Lot 28
Phase North
Model Custom

ROSANNE & NICK CORTELLUCCI

Colours Upgrade Report
The Castles of King City Print Date:12-Apr-17

ELECTRICAL
+ REVISED PLUMBING
+ REVISED FIREPLACES

BASEMENT FLOOR PLAN ELEV. 'A'

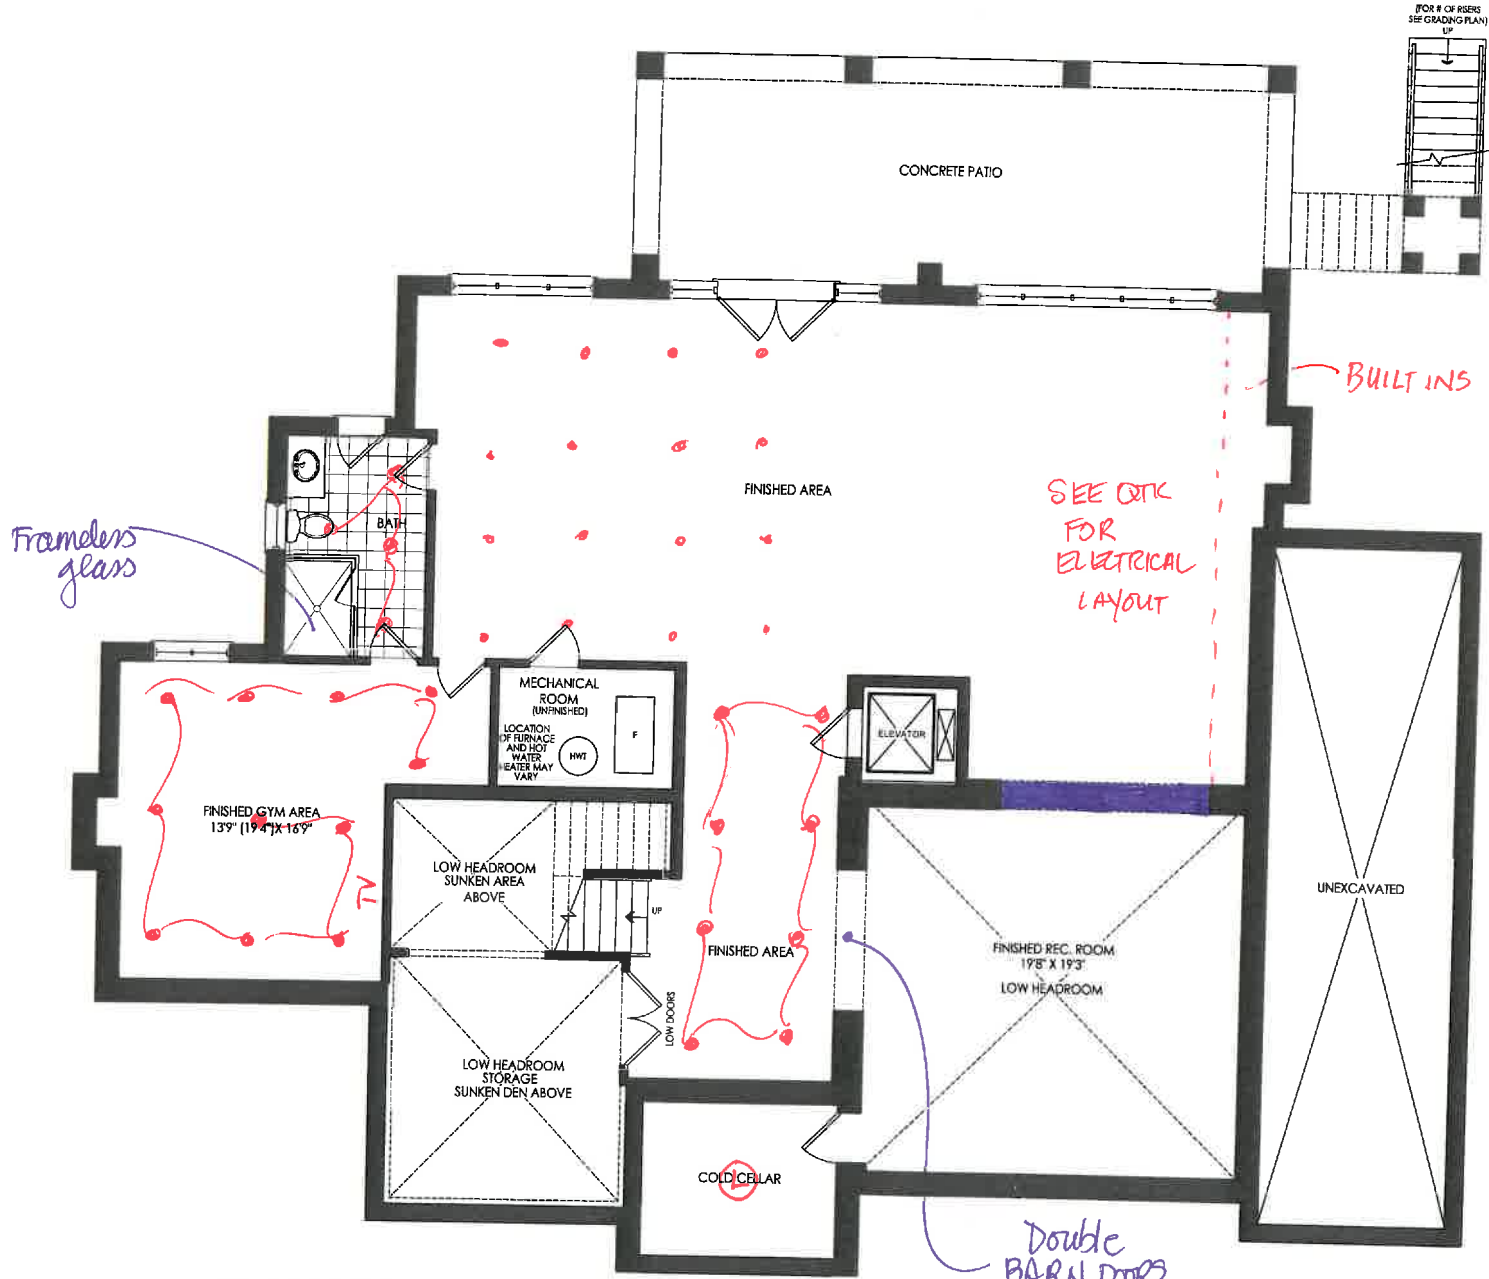
5076	STRUCTURAL	ELECTRICAL - BASEMENT **SEE QTK DRAWING AND FLOOR PLAN 1. REC ROOM (12) LIGHTS ON SEP SWITCH, DELETE STD; (14) POTS IN FRONT OF BUILT INS AND AT BASEMENT BAR ON SEP SWITCH; (2) CAPPED LIGHTS ABOVE ISLAND ON SEP SWITCH 2. REC ROOM IN FRON OF BATHROOM - (16) POTS ON SEP SWITCH, DELETE STD 3. HALL - (8) POTS ON SEP SWITCH, DELETE STD 4. THEATRE - LIGHTING TO BE DETERMINED 5. GYM - (11) POTS ON SEP SWITCH, DELETE STD 6. BATHROOM - (4) POTS ON SEP SWITCH	882		
5077	STRUCTURAL	TRIM - DOUBLE BARN DOORS TO THEATRE ENTRANCE IN BASEMENT	882		
5078	STRUCTURAL	HVAC - NOTE - FAN IN MASTER ENSUITE WATER CLOSET AND MAIN AREA OF BATH	882

CLIENT: ZANCOR HOMES	JOB NAME: LOT 28 CKC	ROOM: KITCHEN	DRAWN BY: RP	COMMENTS: SINK WALL ELEVATION
SITE: CASTLES OF KING CITY	DOOR STYLE: —	DOOR HANDLE: —	SCALE: 1/2" = 1'-0"	
PHONE: —	FINISH: —	DRW HANDLE: —	DATE: DEC 19, 2016	
EMAIL: —	SPECIES: —	TOP: —	PAGE: 2/6

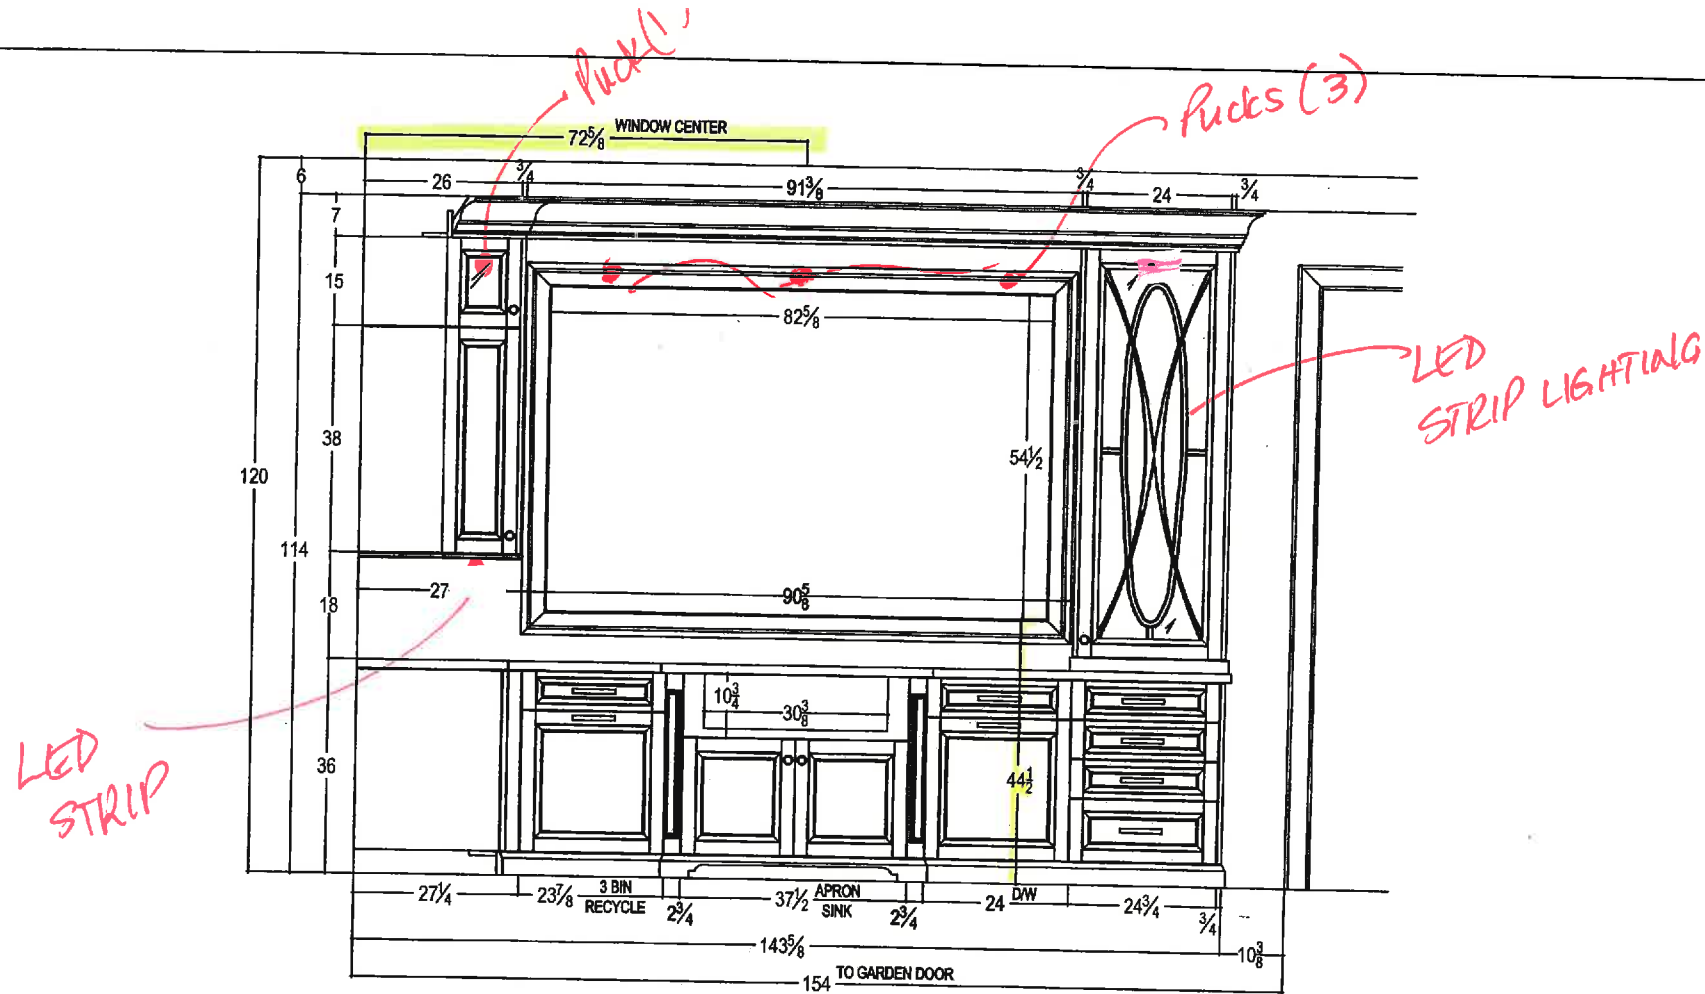
5086	STRUCTURAL	ELECTRICAL - SEE QTK DRAWINGS 1. KITCHEN SINK WALL - (4) PUCKS INSIDE TOP OF UPPERS; LED STRIP TO GLASS CABINET AND UNDERSIDE OF UPPERS 2. KITCHEN STOVE WALL - (4) PUCK LIGHTS INSIDE TOP OF UPPER CABINETS; LED STRIP TO UNDERSIDE OF UPPERS 3. KITCHEN - FRIDGE WALL **NO LIGHTING 4. KITCHEN ISLAND - PLUG FOR BUILT IN MICROWAVE 5. KITCHEN - SSERVERY & PANTRY - LED STRIP LIGHTING INSIDE TOP OF UPPERS AND UNDERSIDE OF UPPERS 6. FAMILY ROOM - BUILT-IN - (7) PUCKS INSIDE TOP OF UNIT; PLUG FOR TV 7. MASTER ENSUITE - (2) WALL SCONCES IINSIDE MIRROR - DIMENSIONS ON QTK ELEVATION 8. MASTER BED WALK IN CLOSET - (2) WALL SCONCES INSIDE MIRROR - DIMENSIONS ON QTK ELEVATION; LED STRIP LIGHTING FOR ALL CLOSET CABINETS; (7) PUCKS IN GLASS UPPER CABINETS 9. DEN - (2) SCONCES IN BUILT-INS, DIMENSIONS ON QTK ELEVATION; LED STRIP LIGHTING IN GLASS CABINETS 10. KIDS LOFT - PLUG FOR TV; ??? LIGHTS IN OPEN SHELVES TO BE DETERMINED 11. LAUNDRY - LED STRIP TO ALL UNDERSIDE OF CABINETS (NOT WHERE HANDING ROD IS) 12. ENSUITE 2 - (1) WALL SCONCE - DIMENSIONS ON QTK ELEVATIONS 13. ENSUITE 3 - (1) WALL SCONCE - DIMENSIONS ON QTK ELEVATIONS 14. BASEMENT BATH - (1) WALL SCONCE - DIMENSIONS ON QTK ELEVATIONS 15. BASEMENT WINE WALL - LED STRIP LIGHTING FOR CABINETS 16. BASEMENT WALL UNIT - (4) PUCKS AT TOP OF OPEN SHELVES; PLUG FOR TV; LED STRIP LIGHTING TOGLASS CABINETS AND UNDERSIDE OF CABINETS	882

CLIENT: ZANCOR HOMES	JOB NAME: LOT 28 CKC	ROOM: KITCHEN	DRAWN BY: RP	COMMENTS: FRIDGE WALL ELEVATION
SITE: CASTLES OF KING CITY	DOOR STYLE: —	DOOR HANDLE: —	SCALE: 1/2" = 1'-0"	
PHONE: —	FINISH: —	DRW HANDLE: —	DATE: DEC 18, 2018 —	
EMAIL: —	SPECIES: —	TOP: —	PAGE: 4/6

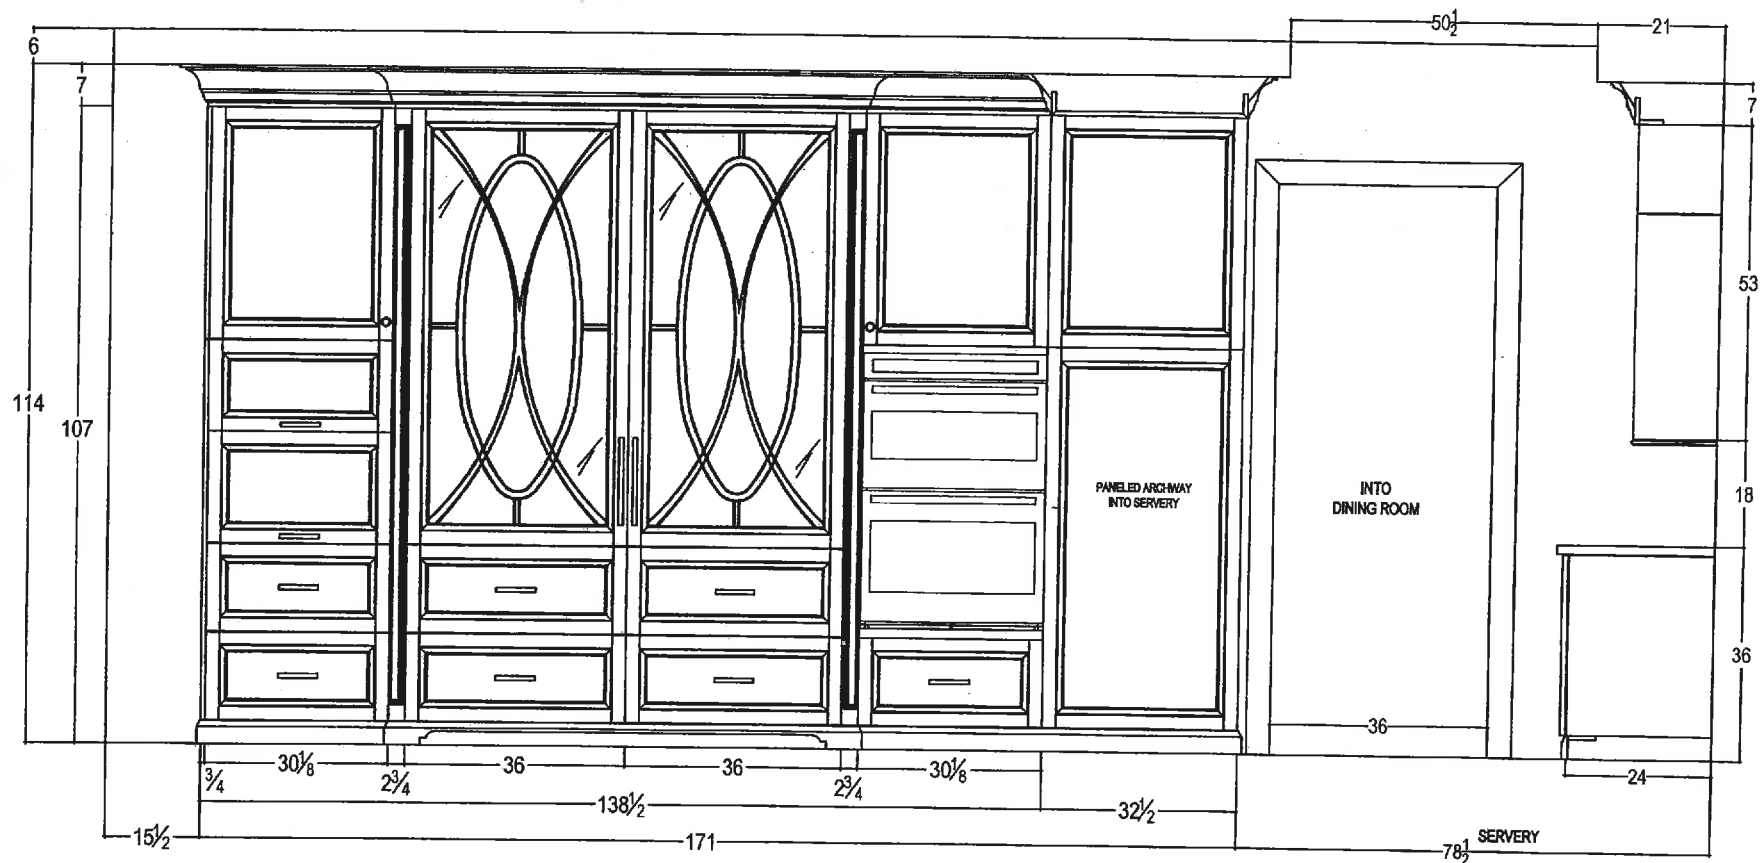
NO LIGHTING HERE

CLIENT: ZANCOR HOMES	JOB NAME: LOT 28 CKC	ROOM: FAMILY ROOM	DRAWN BY: RP
SITE: CASTLES OF KING CITY	DOOR STYLE: —	DOOR HANDLE: —	SCALE: 1/2" = 1'-0"
PHONE: —	FINISH: —	DRW HANDLE: —	DATE: NOV 16, 2016
EMAIL: —	SPECIES: —	TOP: —	PAGE: 1/2

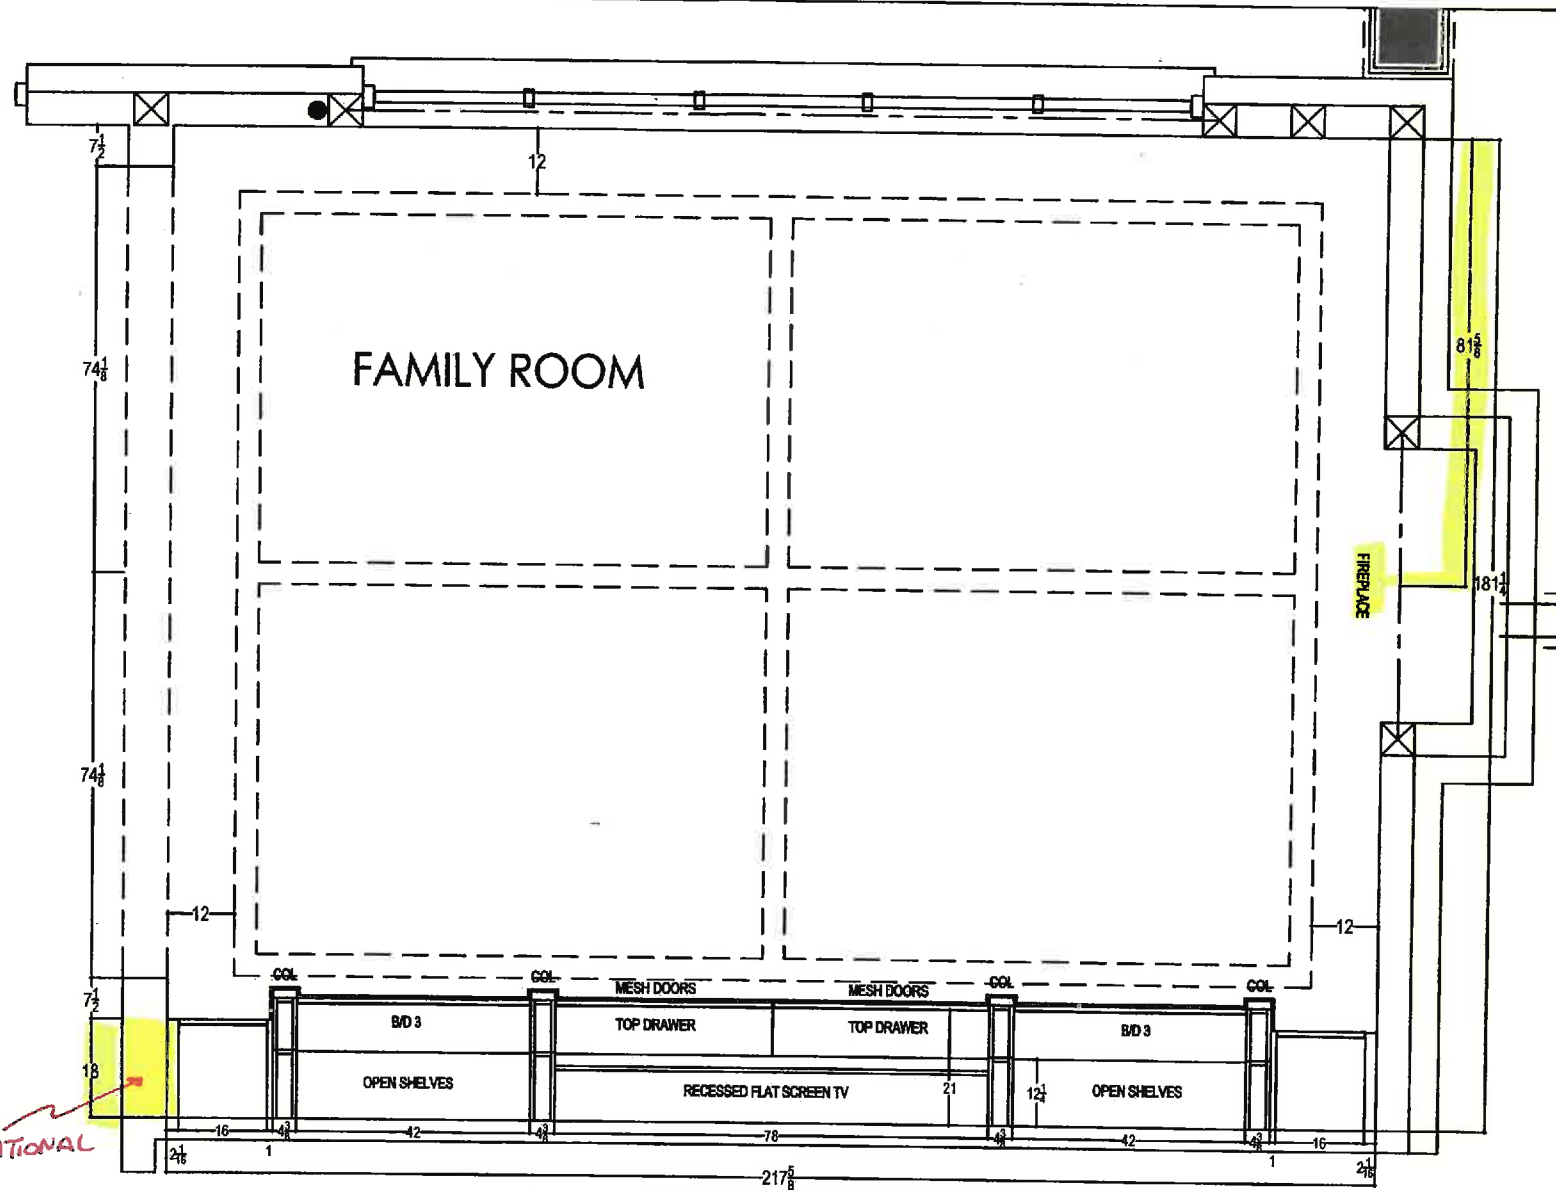
PACK OUT
WALL ADDITIONAL
18"

BED 3 ENSUITE 3

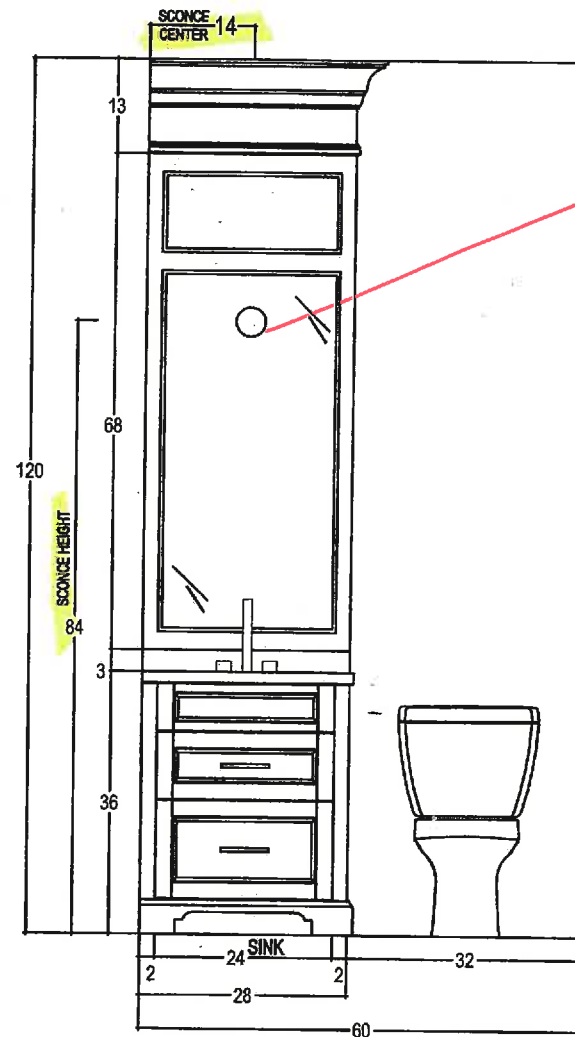
ORIGINALY A TUB
CLAUDIA REQUESTED
A GLASS SHOWER

*SIMONE PLEASE
CONFIRM IF THIS
IS POSSIBLE
